MEETING MINUTES – DAT #4

PROJECT	**BVSD Fairview High School**	MEETING DATE	**2025.04.02**
ATTACHMENTS	Sign-In Sheet PDF Presentation		
BY	Ayla Hendrickson, MOA ARCHITECTURE	LOCATION	Fairview High School

CTE Computer Lab 225

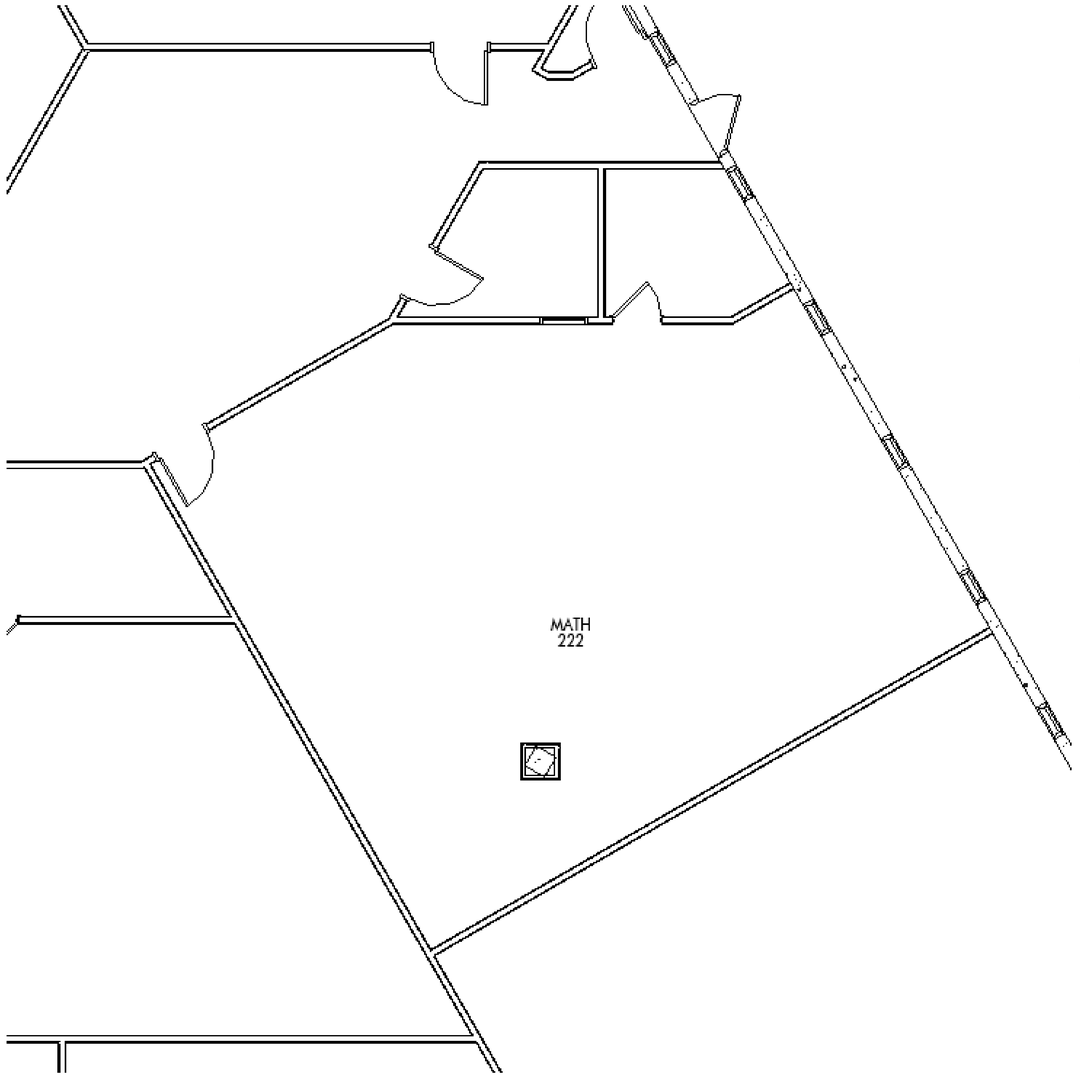
b. Computer Lab 225 and Business 228
        i. MOA reviewed layout of CTE Computer Lab 225
            - Computer Lab teacher concerned about solution for integrating all of the required data and electrical while keeping the classroom collaborative and flexible. Team aligned on a fixed casework solution with casework arranged around knee walls containing power and data. MOA to develop for next DAT.

- Computer Lab teacher approved of teaching wall location shown in diagram.
            - MOA discussed that the size of the room would likely require at least two doors for exiting. This door should have a recess to avoid swinging into people in the hallway. MOA to review and include in update for next DAT.

- Team discussed keeping what is currently an existing office in between 225 and 228. Team aligned on demolishing the office and proposing adding a door and updating the finishes to Office 234 as a compromise.

Library 450 and AV 461 CTE Scope

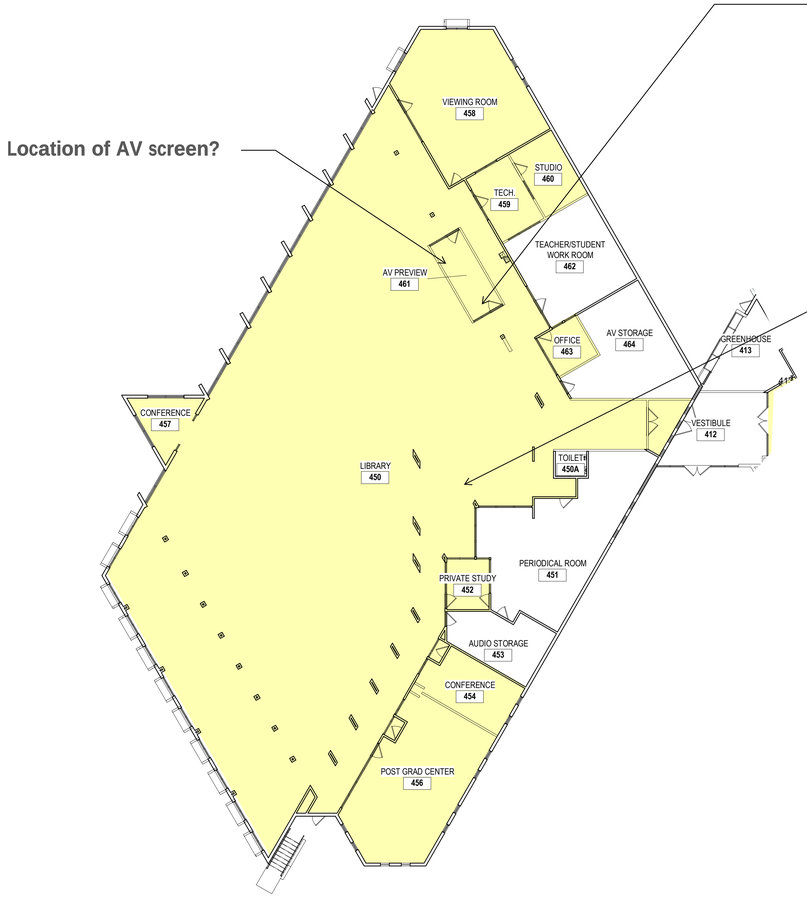
3. CTE scope
    a. Library
        i. Team discussed location of AV projector in Library. MOA proposed location different to what was discussed prior – new location on large wall at AV 461. BVSD will follow up with librarian to reach a decision.

Location of AV screen?

SCIENCE WING SCOPE
FAIRVIEW HIGH SCHOOL

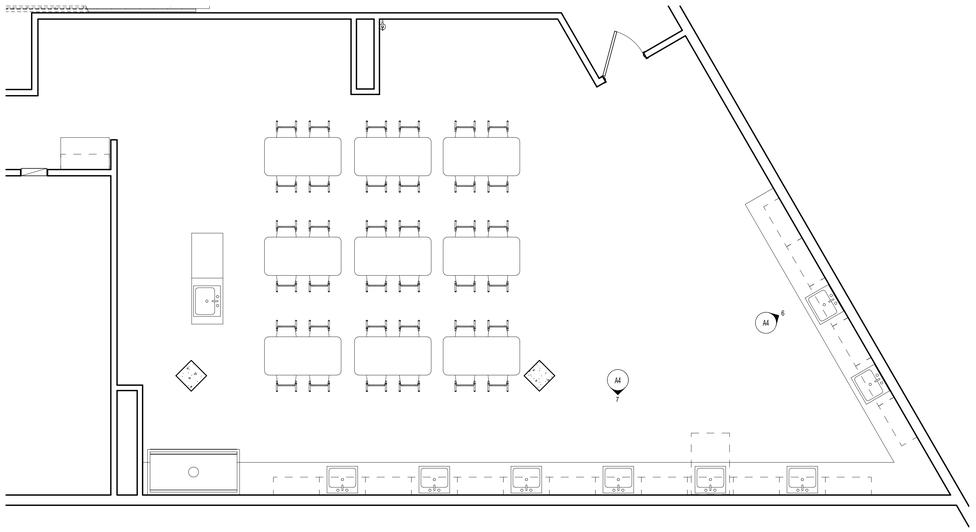
4. Science wing
    a. MOA reviewed that the SD Estimated Budget came in significantly more than what was allocated in the VFA for the science wings. MOA reviewed base scope for each room and the recommendation to move forward with only one room to upgrade to a full chemistry lab.

b. Science teacher clarified that if only one room would be upgraded, that faculty would prefer Physical Science/Geology 408 to be upgraded, not 405. 405 is larger of the two, however it is functioning fine and 408 is in more need of improvement.

c. Science teacher otherwise approved of the scope as defined for 405 for room 408. This scope includes 8 new perimeter sinks. MOA to develop elevations and layout for 408 further.

SPECIAL EDUCATION 811

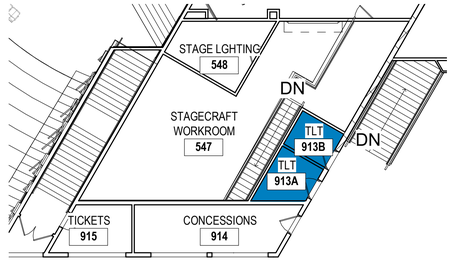
5. Miscellaenous
    a. MOA discussed other miscellaneous interior scope. MOA recommends removing scope for the sink in Special Education 811 and Restrooms 905/906 because both areas appear to be in good shape. Team discussed the gym scoreboards and aux gym sound system.

NOT INCLDUED - ADA COMPLIANT

RESTROOMS

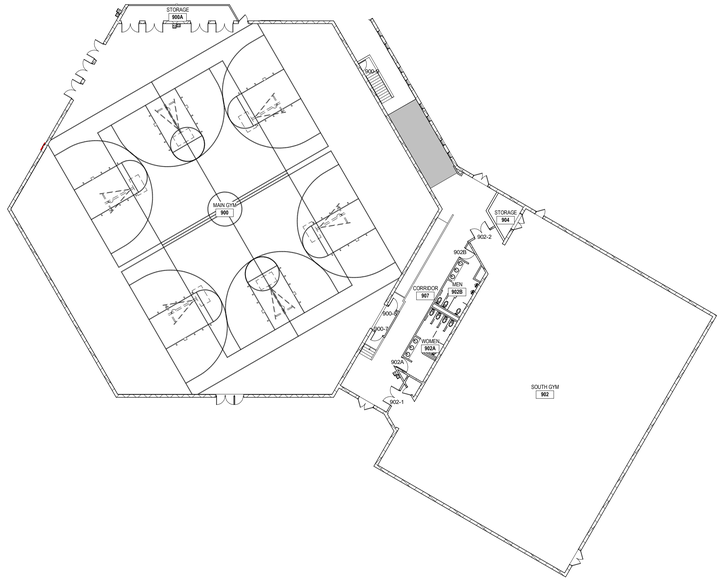
NOT INCLDUED - APPEAR TO BE IN GOOD SHAPE
